PPC Power & GND Pins

MPC8548 Core Power(1.1V) Generation

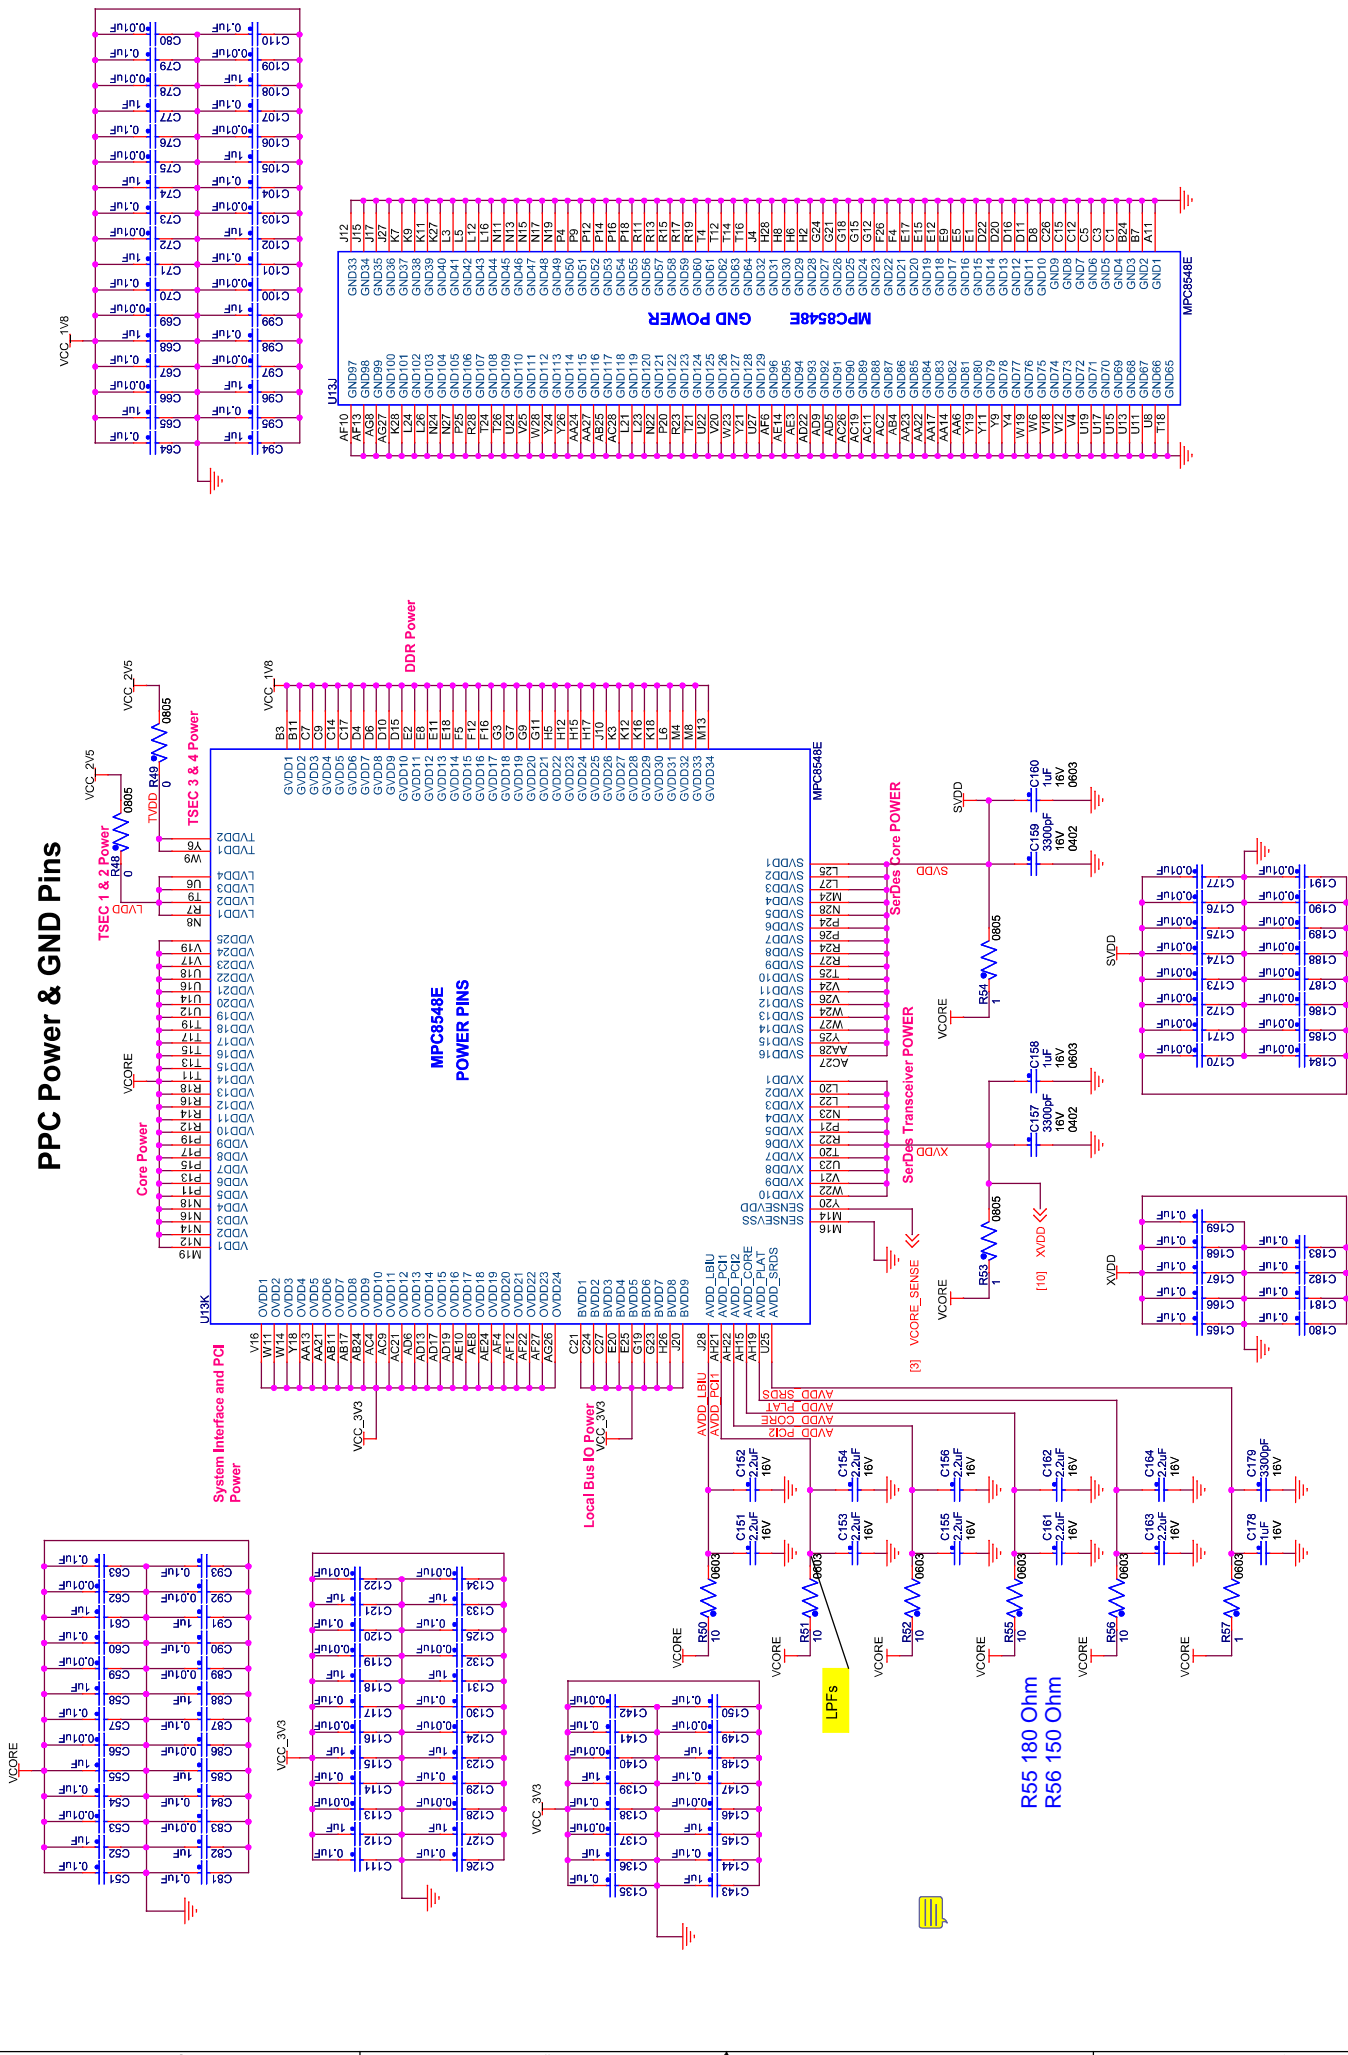
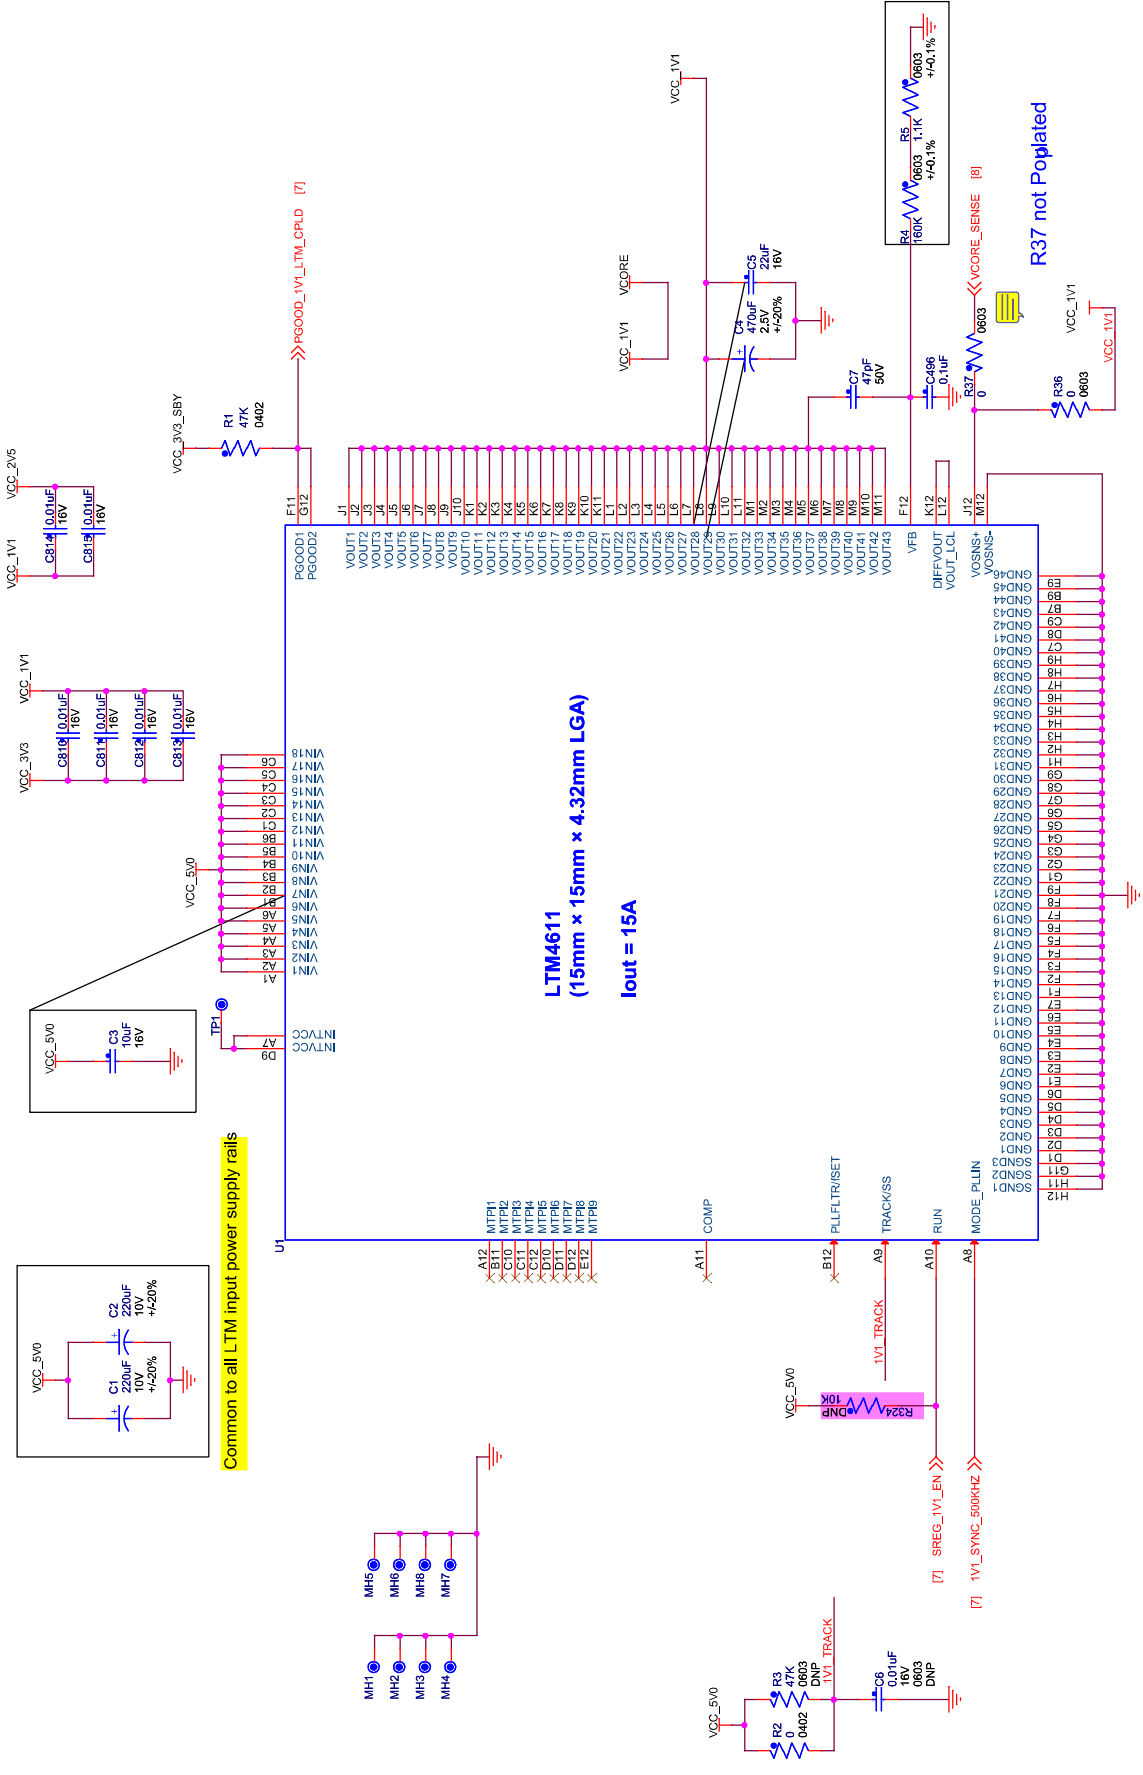
Pin A11 (COMP) and E9 (GND) is missing as per the datasheet. Those two pins were updated.
